SERVICE BULLETIN

SB No. 105 Issue No. 1

TITLE
INSPECTION OF CONTROL SURFACES FOR RUBBING MARKS
CLASSIFICATION

T67B, T67C Series, T67M, T67M-MkII, T67M200, T67M260 and T67M260-T3A.

FIG 1
SECTION BASED ON ELEVATOR
FLAP ANDAILERON SIMILAR

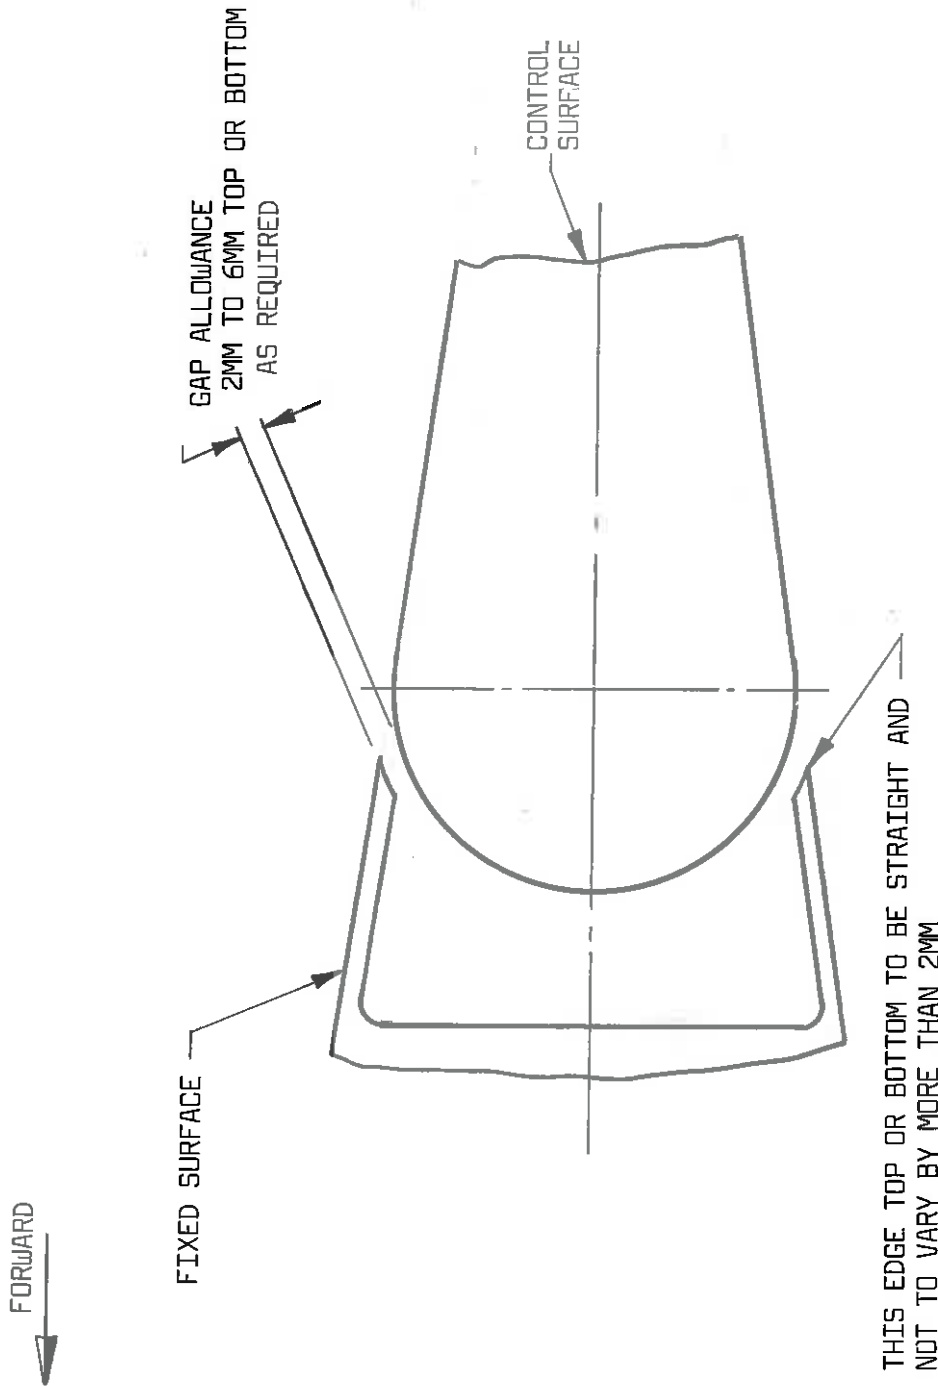
1. Check for rubbing marks on aileron, flap and elevator leading edges.
2. If there is evidence of rubbing between shroud and control surface then the gap may be increased by abrading relevant control surface shroud, ref. Fig. 1.

The shroud to control surface gap increase is to be kept to a minimum. Maximum allowable gap is to be 6mm. Gap along its length not to vary by more than 2mm. Gap to be measured when control surface is in the neutral position.

3. Finally restore shroud edge finish and repair any control surface damage, especially to fabric control surfaces.
4. On completion of rectification work annotate aircraft log book "SB 105 complied with".
